2. AMENDMENT/MODIFICATION NO. 0003	3. EFFECTIVE DATE 7/18/01	4. REQUISITION/PURCHASE REQ. NO.	5. PROJECT NO. <i>(If applicable)</i>
--	-------------------------------------	----------------------------------	---------------------------------------

Design-Build FY01 MCA PN 52265 and BUP PN 52266 , Whole Barracks Renewal, Phase 4A, Renovation of Quad F, Schofield Barracks, Oahu, Hawaii

1. Attached hereto are revised and new pages to Sections 00700 and 01010. The revision mark "(AM-0003)" is shown on each page.

ROADWAY LIGHT FIXTURE

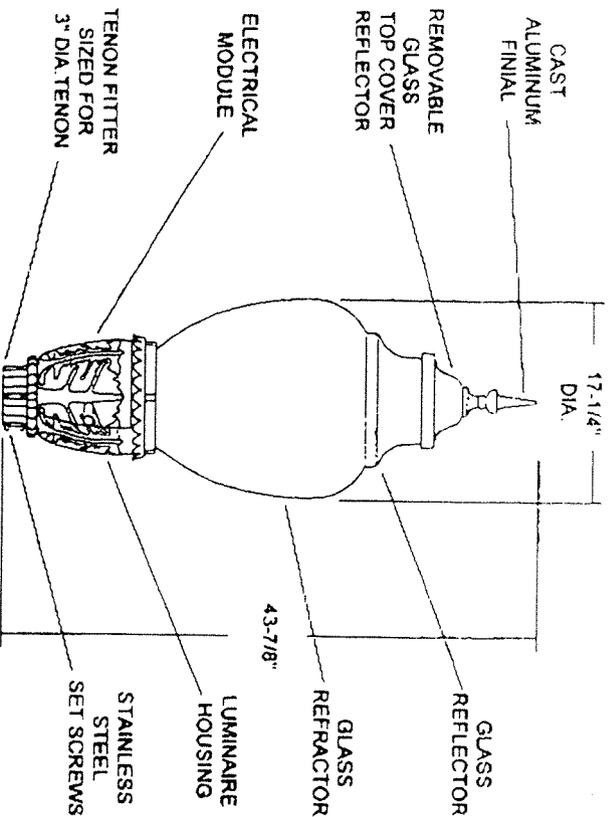
Q46. Please provide information on the type of light post required for this project.
